TAMILNADU INDUSTRIAL DEVELOPMENT CORPORATION LIMITED

E-Tender cum E-Auction of Vacant Plot at Fintech City Nandambakkam, Chennai on Lease basis

<u>Pre Bid Responses</u>

Layout of Land - layout approval

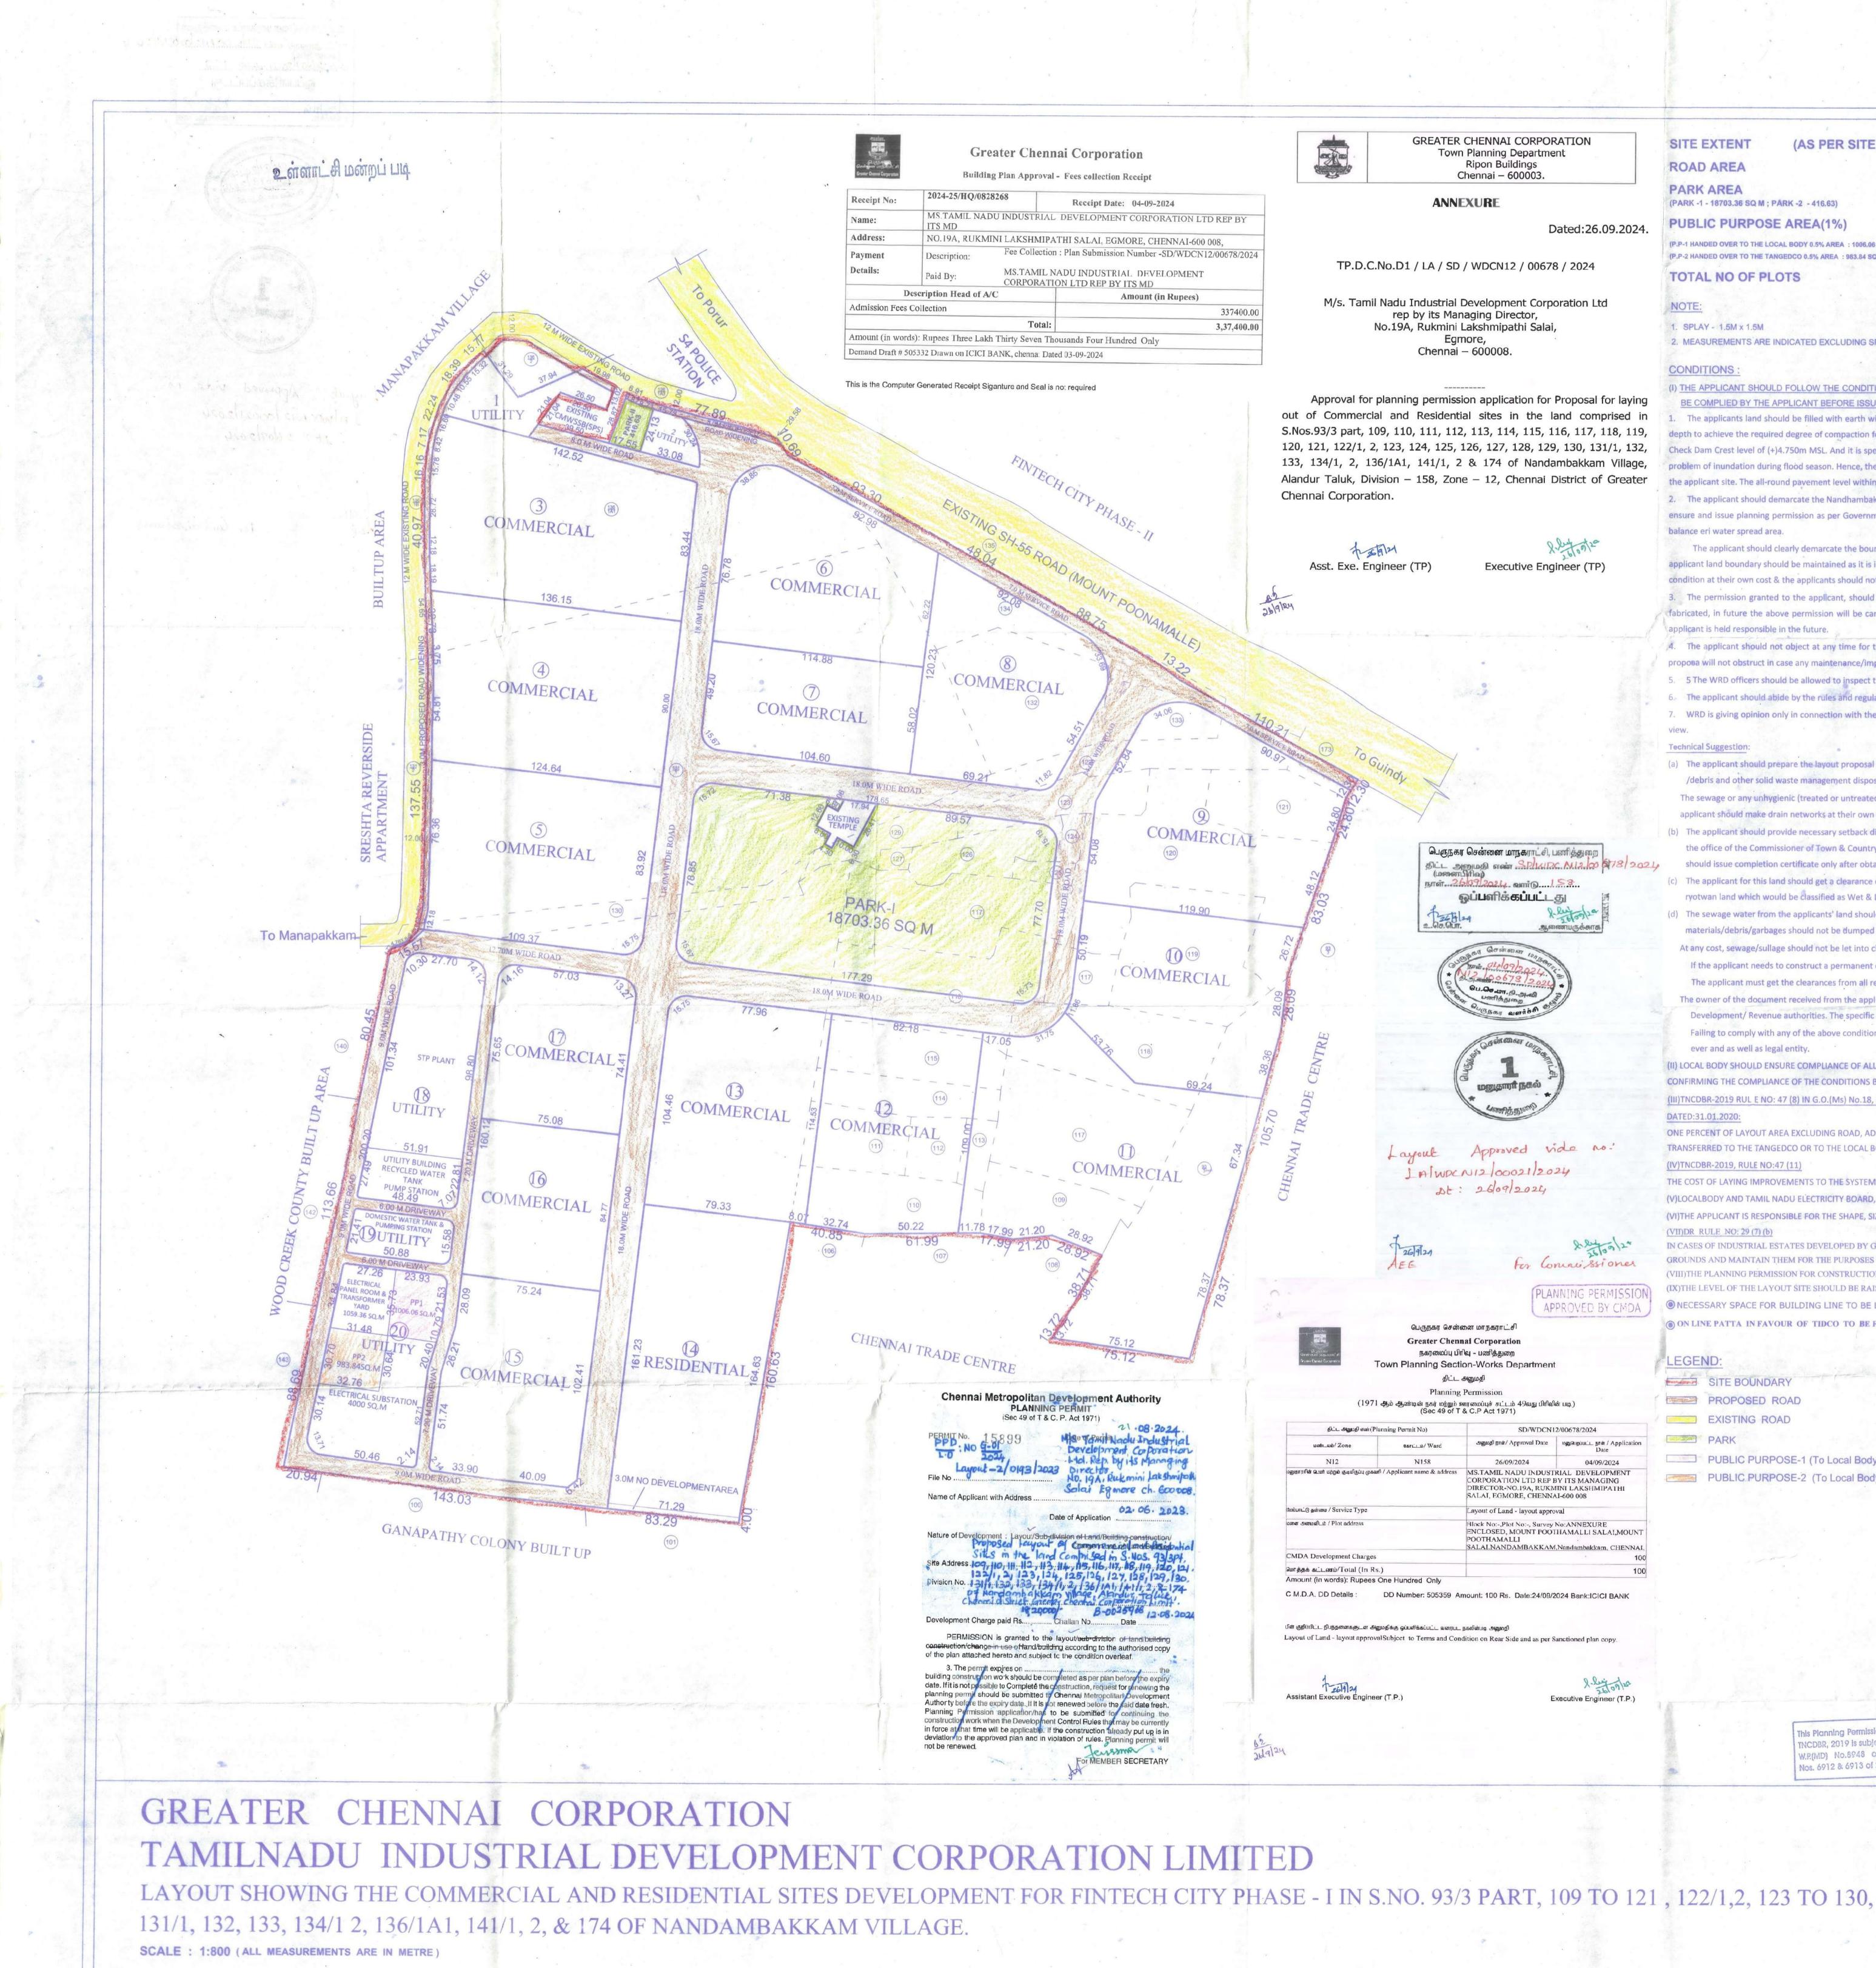
1.	General	Query: Has the CMDA approval been received for this layout. A copy to be shared	Yes, CMDA approved layout is attached as Annexure 1
2.	General	Query: Is there a traffic study report available? Since the plots do not directly about the main road, we need to understand how the ingress and egress has been planned.	Yes, Traffic study report will be shared with the successful bidder only.

4.	General	Query: What is the nature of the plots S1, S2 and A2 which are located in front of S3 plot? Also what is the CMWSSB plot (blue colour) and Gas Station plots (orange) utilised for?	S1, S2 are utility plots. Existing CMWSSB Storm pumping station maintained by metro water as shown in blue colour. Gas station plot will be utilized for only Fintech Tower.

SI.No	Reference as per RFP	Contents of RFP/Queries received from the prospective bidders email/letter	TIDCO's Clarifications/Replies
6.	General	Query: Autocad drawing of the layout to be shared	The CAD file will be shared with the selected bidder. However, a PDF file of the CMDA approved layout is attached at Annexure 1
